Recommended Changes to be Adopted with the Peery Park Specific Plan

Staff Recommended Changes to the Peery Park Specific Plan Document				
	Current PPSP Section	Current Provision w/ Changes	Proposed PPSP Section	Notes to Describe Change(s)
1	2.2.1.B.2. Page 49	<u>Residential development projects</u> in the Neighborhood <u>Transition</u> district shall.....pertaining to the <u>processes, procedures and development standards</u> pertaining to the Medium Density Residential (R-3) zoning district with the following <u>two</u> exceptions.....	Same	Clarification of intent
2	2.2.1.B.2.b. Page 49	<u>Residential Development</u> shall conform to Section 2.2.2. <u>C.1.a</u>	Same	Clarification of intent
3	Table 2.1 Page 53	S1: Permitted on upper.....District Activity Center requirement is met <u>in conjunction with the Activity Center use of the site. May not apply to the Activity Center overlay when parcels are used for industrial/office/R&D uses</u>	Same	Office/Industrial and other similar uses are allowed on the ground floor in the Activity Center overlay or in the Activity Center if not used in the District Activity Center manner. Clarification needed

1. Updated Fig. 4.3.3.A & B Bicycle

FIG. 4.3.3.A BICYCLE NETWORK IMPROVEMENTS

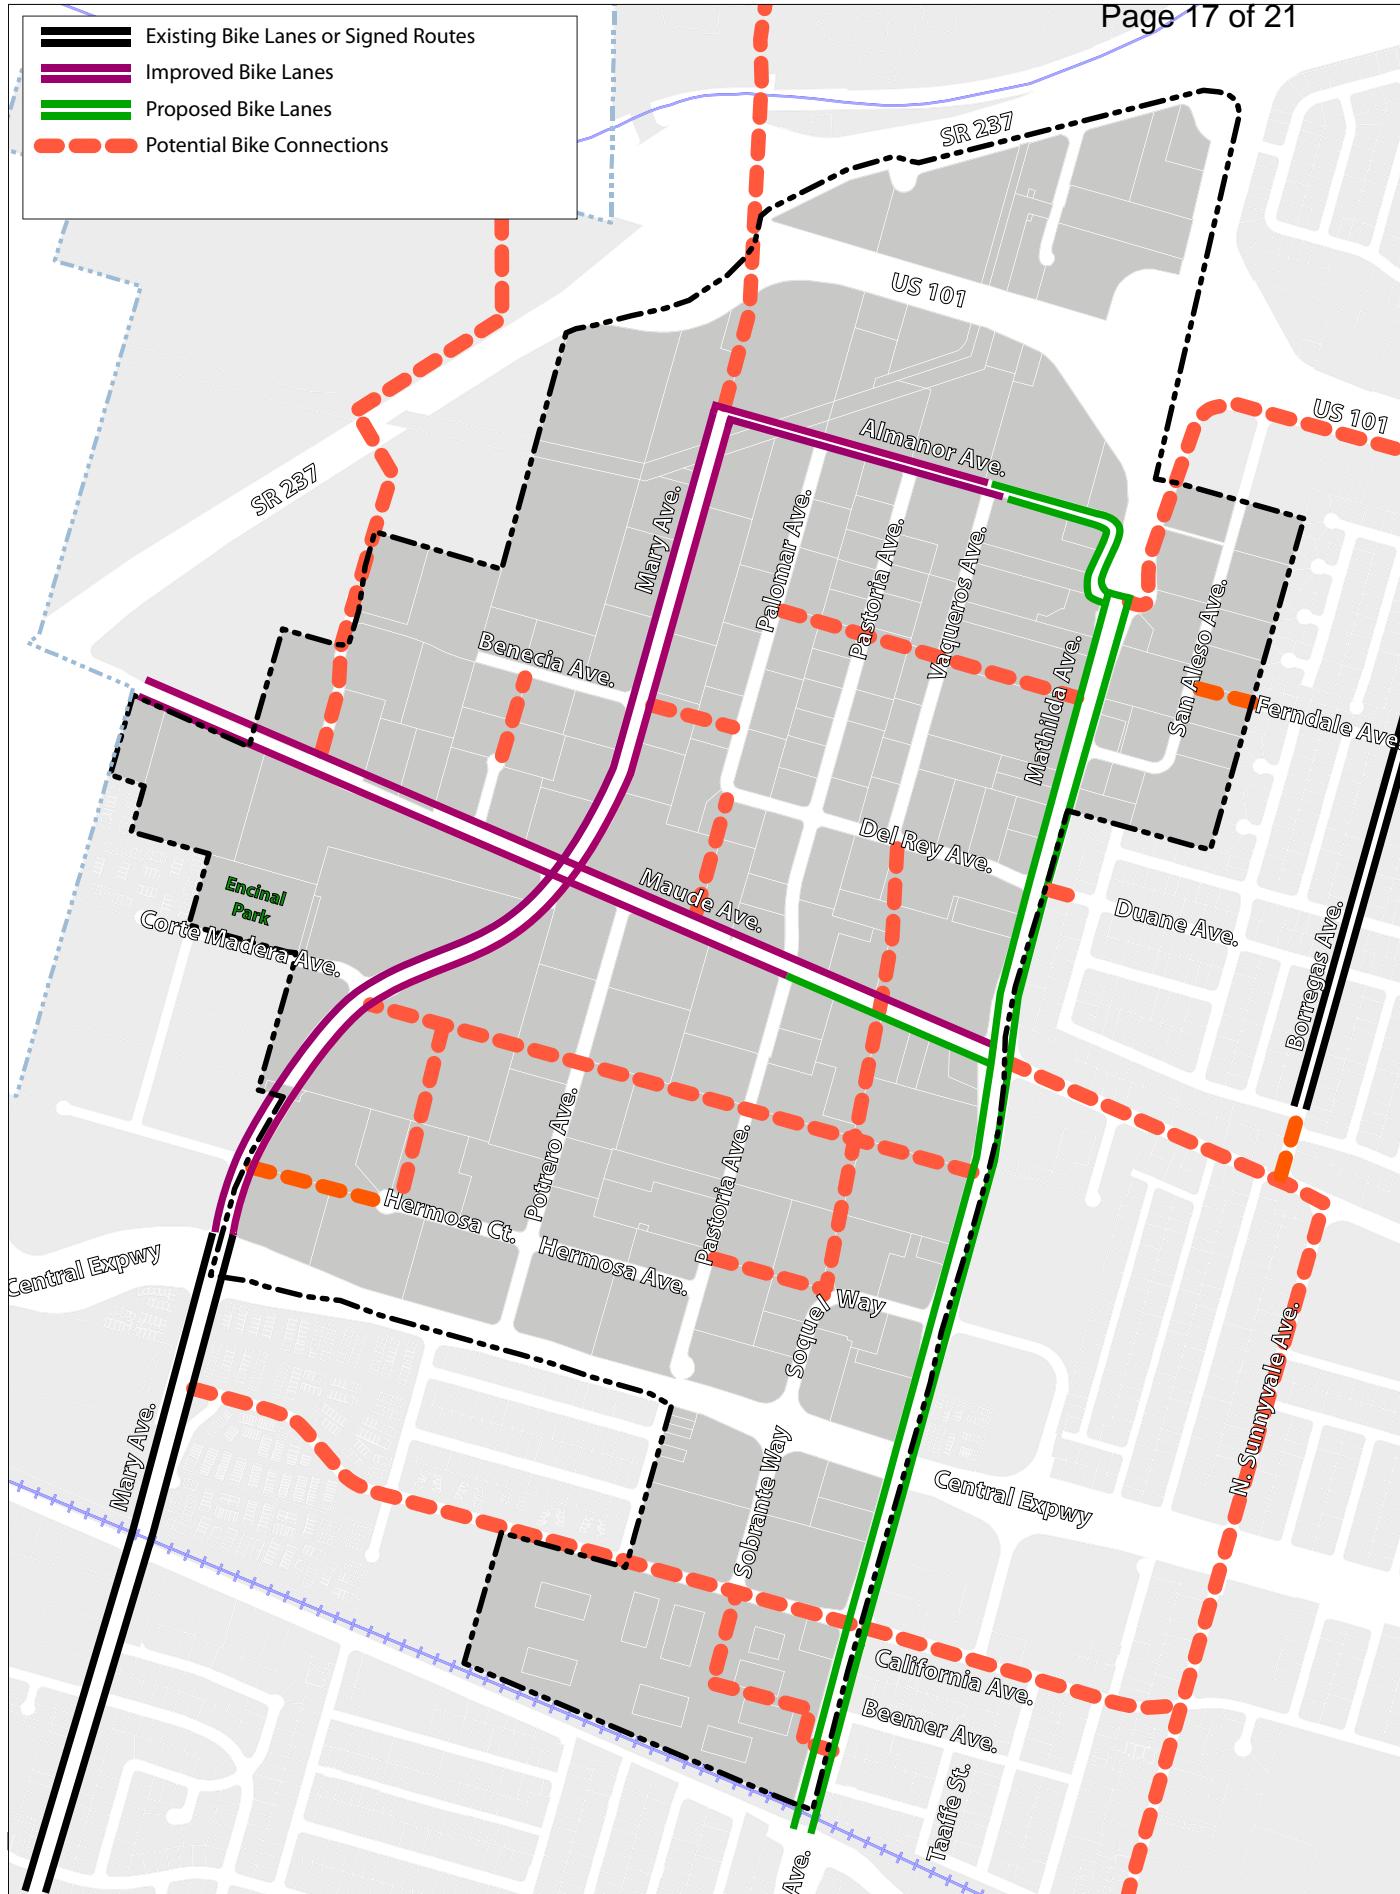
18	4.3.3.B Page 136	Add additional potential pedestrian connections throughout the district. Shown in Attachment 1 of this document.	Same	More public pedestrian connections through the district will help to make the district more vibrant and active and will help to accomplish many of the PPSP objectives.
19	4.6 Page 140	Shuttle (or bus) Stops: Improvements include bus shelter, site improvements and construction at transit stops of the future Peery Park Rides service area and other potential Peery Park shuttles	Same	The intention was these stops could be for Peery Park Rides or for a future shuttle program for the district.

Page 33	release of the draft PPSP. The correct version is on page 123, Fig. 4.3.1.C. Change the Book 1 version to match Book 4.		
11	Figure 1.8.C.1 Page 41	We updated this map prior to the release of the draft PPSP. The correct version is on page 135, Fig. 4.3.3.A. Change the Book 1 version to match Book 4. Additionally, correct Benecia to show the entire roadway (correct roadway shown on map on Page 23).	Same	
12	Figure 1.8.C.2 Page 42	We updated this map prior to the release of the draft PPSP. The correct version is on page 136, Fig. 4.3.3.B. Change the Book 1 version to match Book 4.	Same	
13	Fig. 1.9 Page 45	Should be labeled 1.8 Additionally, correct Benecia to show the entire roadway (correct roadway shown on map on Page 23).	Same	
14	2.0 Page 47	2 nd sentence: "The Development Code is used to evaluate development projects, improvement plans, and zoning clearance applications <u>conditional use permits</u> ."	Same	This is old wording based on the previous process title we were using in the admin version of the PPSP.
